RTCA Paper No. 049-23/SC214-141
EUR 087-23 / WG78-57

EUROCAE WG-78 Plenary # 34 / RTCA SC-214 Plenary # 43 “Standards for Air Traffic Data Communication Services” - Minutes
--

Date	January 30 – February 2, 2023
Place	Melbourne, FL, USA
Hosted by	Collins Aerospace

2.1 Interop Volume 1 Comment #87 Showstopper, Backward Compatibility, Mike Matyas (Boeing)

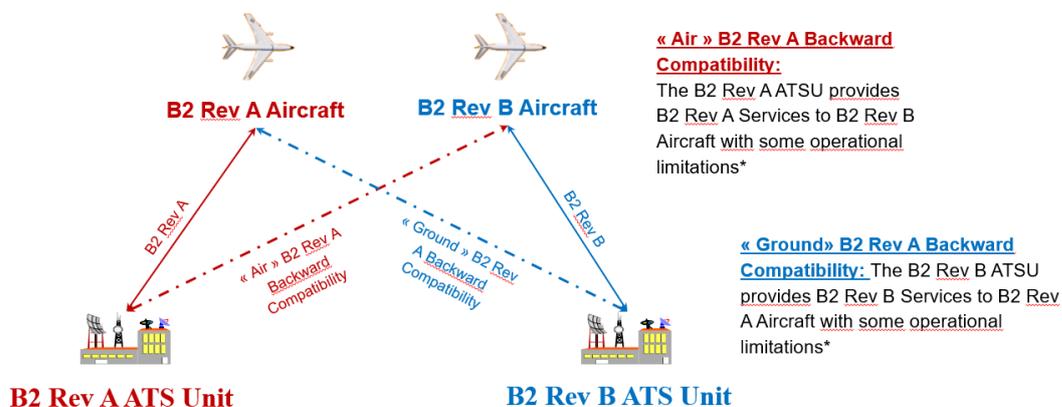
Comment: B2 Rev B Backward Compatibility. Maintaining B2 Rev A backward compatibility is not in any way worth the associated cost, schedule, and technical impacts. The avionics would have to implement four CPDLC versions (FANS, B1, B2 Rev A, B2 Rev B) and three ADS-C versions (FANS, B2 Rev A, B2 Rev B) for no real benefit. Additionally, Boeing notes

that maintaining B2 Rev A backward compatibility is not part of the RTCA SC-214 TORs and also significantly increases the risk of not meeting the CP1 mandate schedule. Boeing will implement only one B2 version, either Rev A or Rev B.

Mike Matyas introduced the discussion by stating that full backwards compatibility in the air and on the ground is too costly for avionics manufacturers to implement. For example, including support for rev A B2 and rev B B2 in the logon would lead to 12 different permutations to test. There are UI impacts as well.

The question was raised about revision A ground stations--currently MUAC is the only B2 ground system, and they committed to updating prior to the B2 rollout. Both NATS and MUAC expressed support for the ground managing backward compatibility instead of the aircraft. Thierry Lelievre (Airbus) presented the following to define air vs. ground backward compatibility:

The group agreed to ground backward compatibility and worked through the required changes to DO-351B. They are summarized by:
